Pilot Region-Based Optimization Program for Fund-Lead Sites in EPA Region 3

Site Optimization Tracker: Raymark Hatboro, Pennsylvania

Report of the Remediation System Evaluation,
Site Visit Conducted at the Raymark Superfund Site
June 7-8, 2001

Final Report
December 19, 2001

FIGURE 1-3. CROSS SECTION OF THE GEOLOGY UNDERLYING THE RAYMARK SITE.

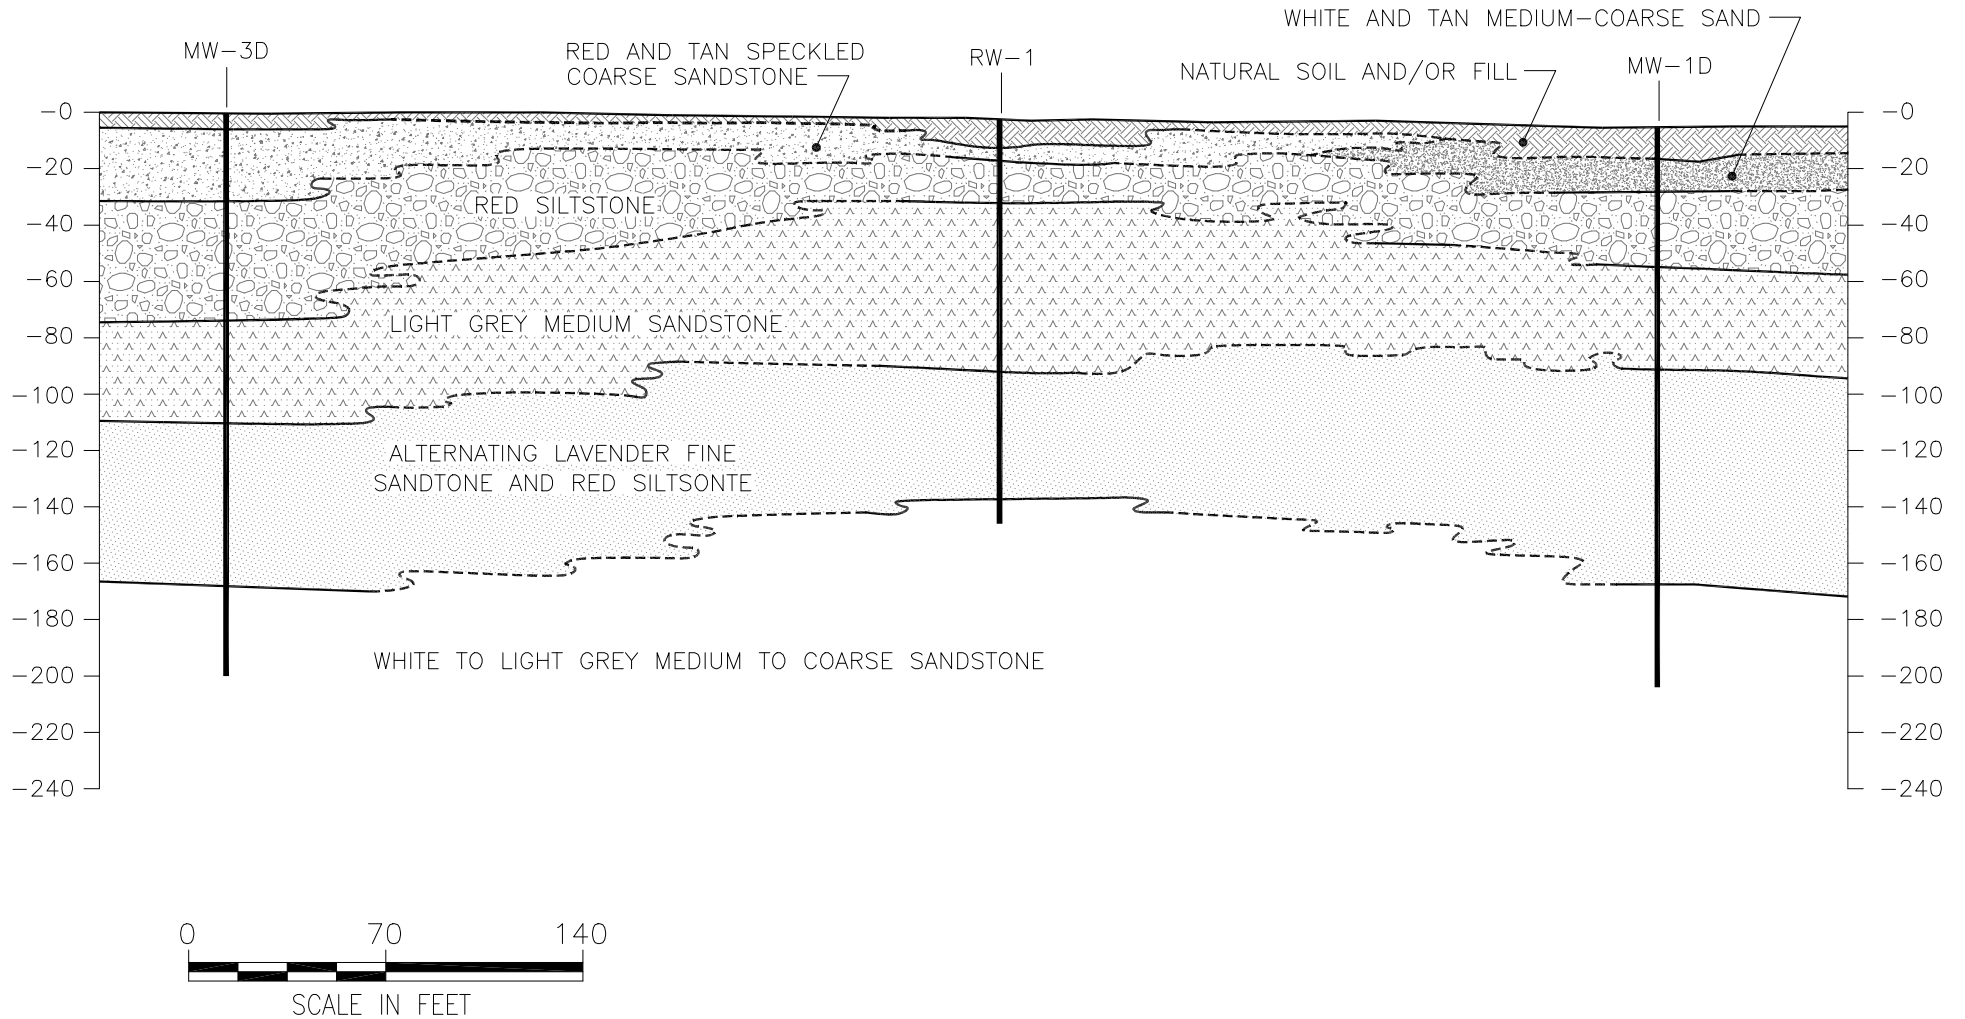
The extent of ground water TCE contamination onsite should be further investigated as well, especially along the site boundaries. A cluster of sampling points each independently screening the stratigraphic units shown in Figure 1-3 and located midway between the MW-3 and MW-2 clusters would help delineate the plume on the western boundary of the site. This is significant given that ground water likely flows to the west toward Pennypack Creek and Hatboro wells H-14 and H-17. Another cluster of sampling points each screening the stratigraphic units shown in Figure 1-3 and located midway between the MW-3 cluster and the rear end of the property (to the east) would help delineate the plume on the southern/western site boundary. This is also significant because Pennypack Creek turns and passes within a mile to the southwest of the site and ground water could be flowing in that direction. These points should be added to the annual sampling program and analyzed for volatile organic compounds (VOCs).
